SITE PLAN & ARCHITECTURAL
COMMISSION
AGENDA
JULY 19, 2019

50.1 **AC-19-047** Consideration of a proposal for the construction of a 4,456 square foot restaurant with drive-thru (McDonald's) and parking area located on a 1.07 acre project site in a shopping center on the north side of East Barnett Road approximately 560 feet east of South Riverside Avenue in the C-R (Regional Commercial) zoning district (371W30DC TL 5900). Applicant: McDonald's Corporation; Agent: AKS Engineering and Forestry; Planner: Liz Conner

REVISED STAFF REPORT

for a Type-III quasi-judicial decision: Site Plan & Architectural Review

Figure 1: Alternate Site Plan

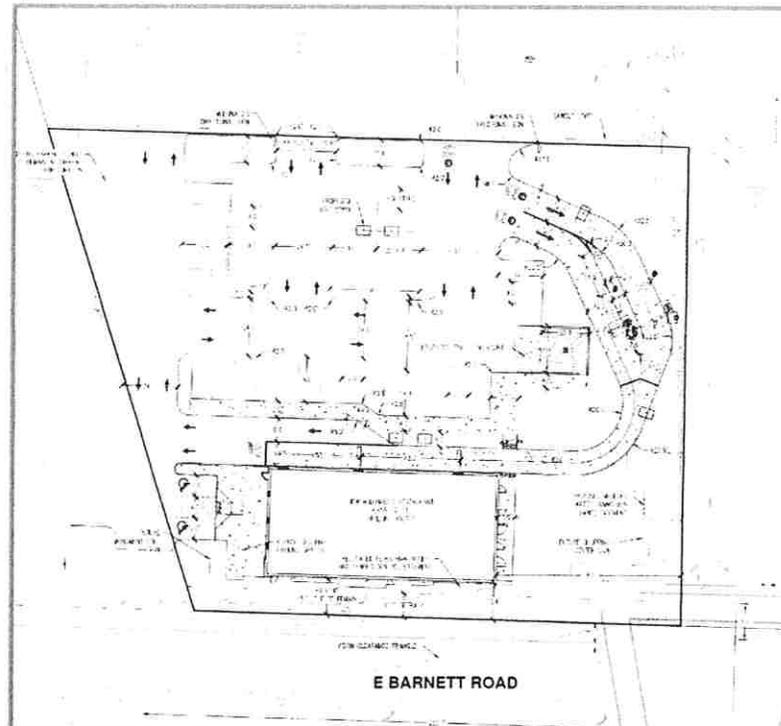
At the first Site Plan & Architectural Commission hearing on June 7, 2019, the agent provided an Alternate Site Plan submitted into the record at Exhibit S as it met the standards of the code. The original site plan (Exhibit B) will remain in the record for any future requests for modifications, but is not recommended or included for approval. The Alternate Site Plan is similar to Exhibit B with the exception of the parking area to the western property boundary.

The proposed site fronts East Barnett Road. The site plan shows parking situated to the rear of the building and adjacent to the shopping center parking area. The drive thru consists of two order points that merge into one lane for pick up, then exits across the parking lot.

Figure 2: Original Site Plan

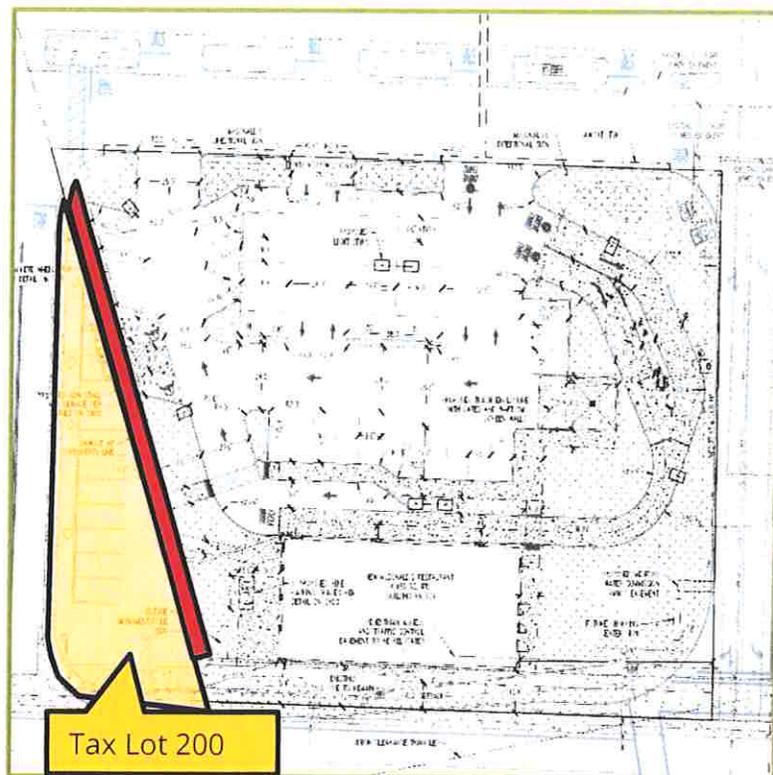
The original site plan (Exhibit B) indicated a pedestrian walkway running northwest along the westerly property boundary identified in red. While the sidewalk would have provided access to the Winco Shopping Center, the design cut off access to the existing developed parking area.

Figure 3: Alternate Site Plan

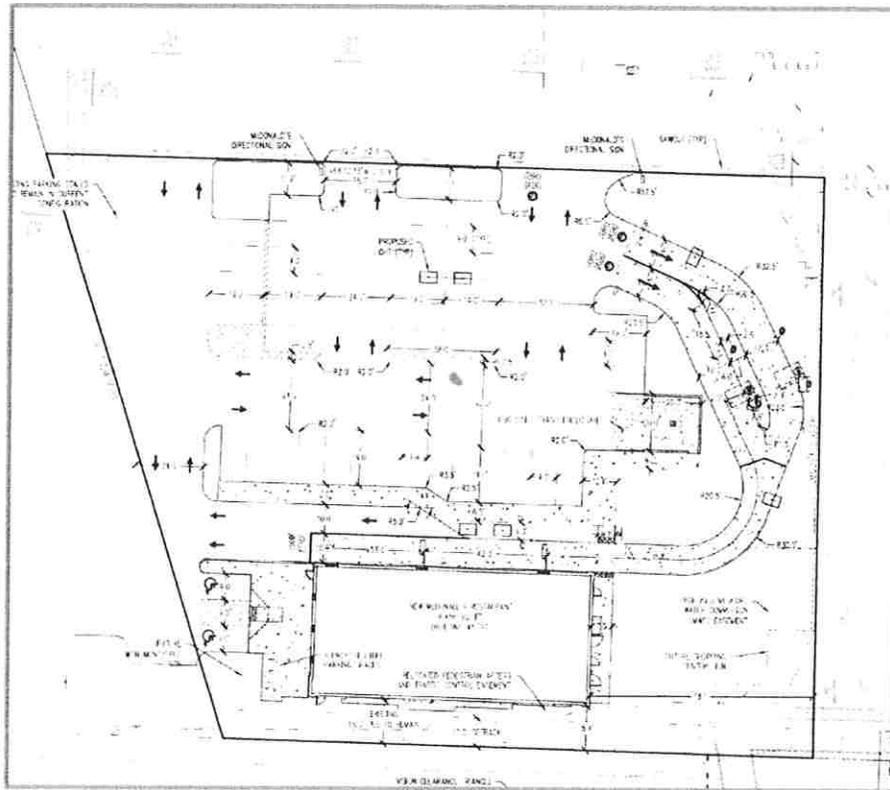
The Alternate Site Plan (Exhibit S) now incorporates the existing parking located on Tax Lot 200 and does not restrict access.

Staff had originally included a condition requiring that the applicant submit a revision to the site plan that does not restrict current and future use of the existing parking spaces located on the adjacent property, Tax Lot 200 to the west. This was completed by the Agent at the hearing as shown in Exhibit S.

Figure 4: Adjacent Properties Exhibit U

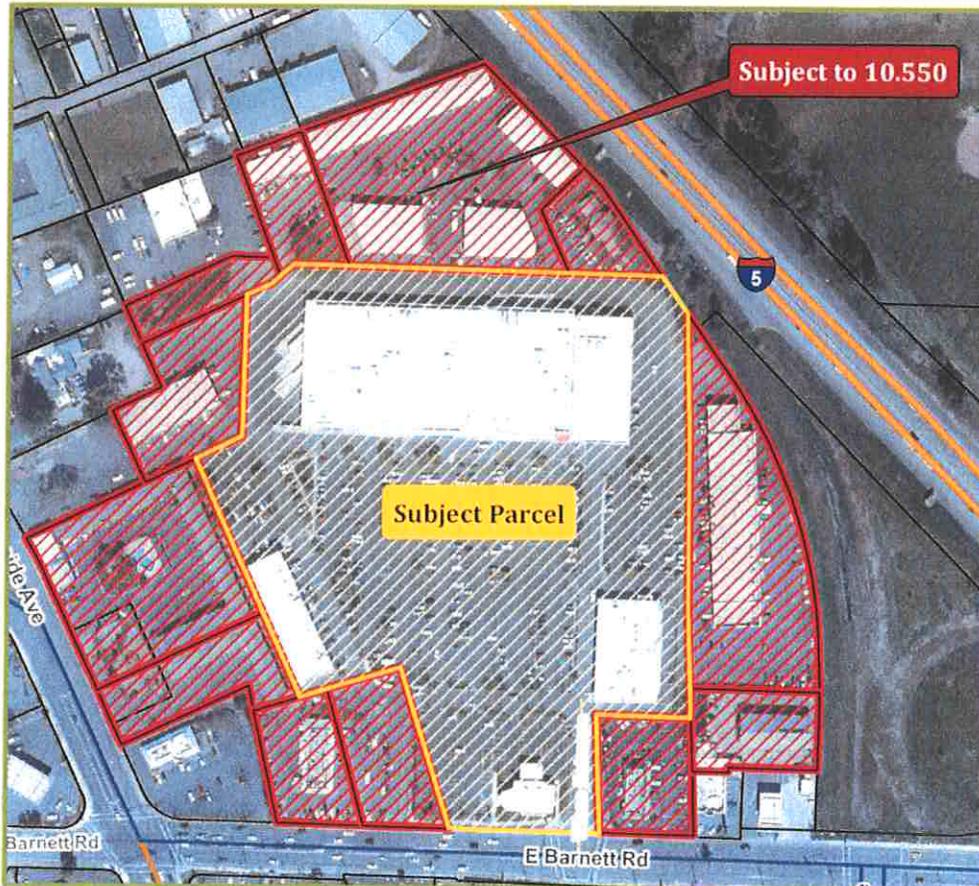
At the June 7, 2019 hearing there was discussion regarding what properties were to be granted cross access by the subject property. The Cross Access Map (Exhibit U) identifies 12 adjacent parcels that shall be granted cross access pursuant to MLDC 10.550(3)(3).

An email provided by the subject properties owner's general counsel (Exhibit V), stated that the owner will comply with granting cross access to adjacent properties.
